Re: Indian Point Unit No. 2
Docket No. 50-247

Subject: Response to the Staff's Requests for Additional Information (RAI) Regarding the Steam Generator Tube Examinations conducted during Spring of 2000 Outage, and the Root Cause Evaluation of the Steam Generator Tube Rupture Event of February 15, 2000 (TAC No. MA8219)

Response to Questions Regarding Steam Generator Tube Examinations
Performed During Spring 2000 Outage

Consolidated Edison Company of New York, Inc.
Indian Point Unit No. 2
Docket No. 50-247
June 2000

Figure 10 Comparison of Tubes Plugged for 0.610" Restrictions

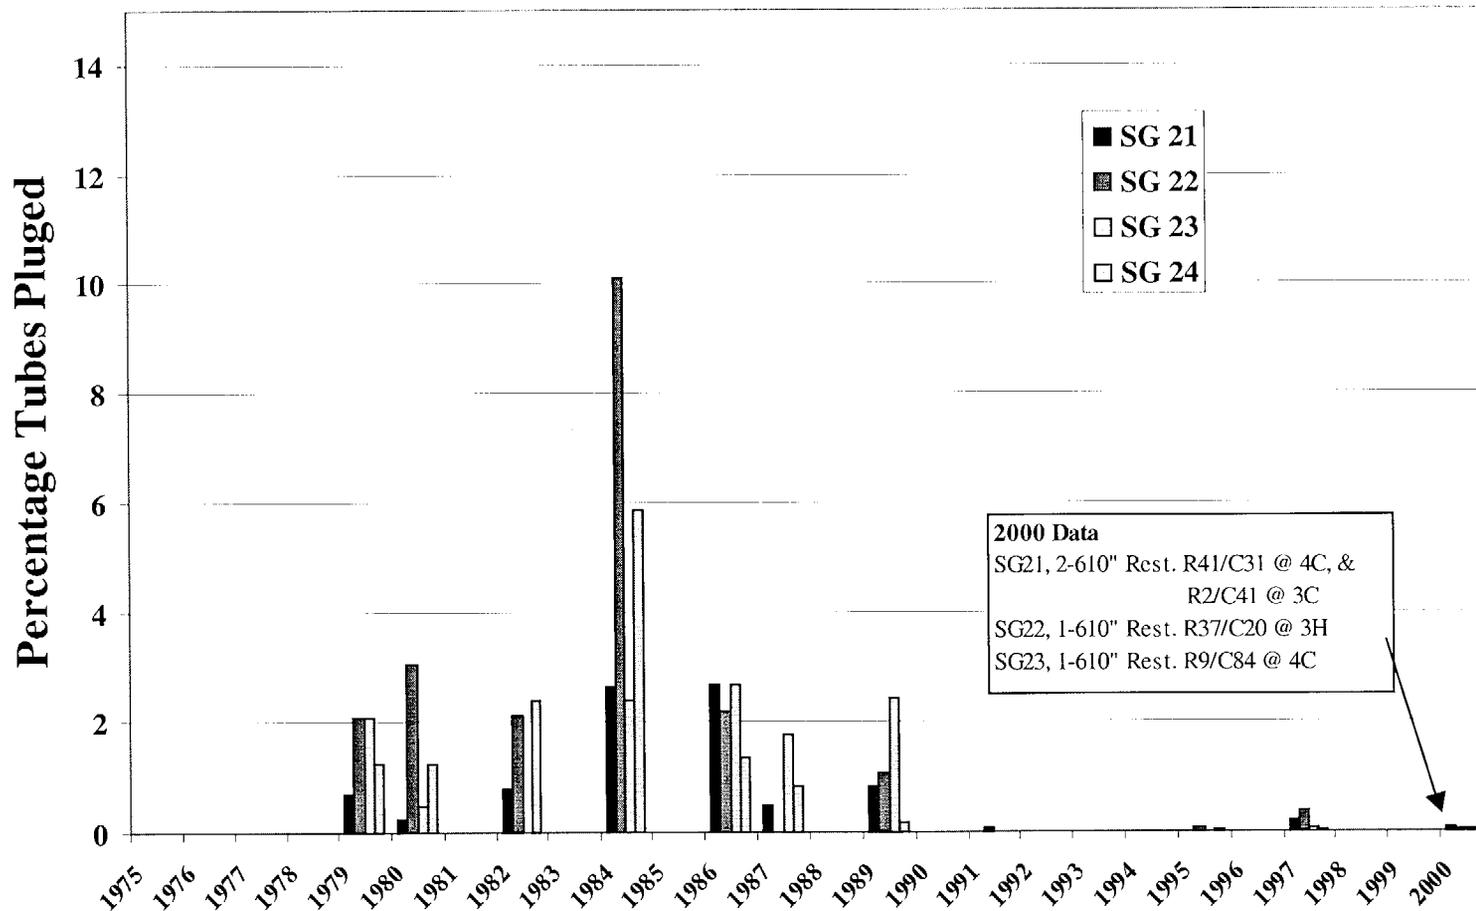
Provide the trending analysis of dents in the upper support plates and ovalization of rows 2, 3, and 4 u-bends. This trending analysis should be displayed in graphical or tabular form as appropriate to best illustrate the trends. A summary discussion should be provided of denting trends in the lower support plates. The licensee's July 29, 1997, inspection reported 20 tubes (mostly in steam generator 22) failed to pass the 0.610 bobbin in rows 2 and 3. Were these tubes able to pass a 0.610 or larger bobbin in earlier inspections? Have the row 2-4 u-bends been inspected with bobbin during the current inspection so as to contribute to the above trending analysis?

Figure 10 shows the number of tubes plugged for 610 mil bobbin probe restrictions as a percentage of the number of tubes inspected each outage since 1975. Tubes that are restricted to the 610 mil bobbin probe were plugged in accordance with the IP2 Technical Specifications.

- The number of tubes plugged as a percentage of those inspected has decreased from 2.5% – 10% in 1984 to <0.1% in 2000 (Figure 10).
- Most of the locations where a direct comparison between 1997 and 2000 could be made showed no change in restriction size (Tables 1-4).
- The rate of flow slot closure has leveled off since 1985.
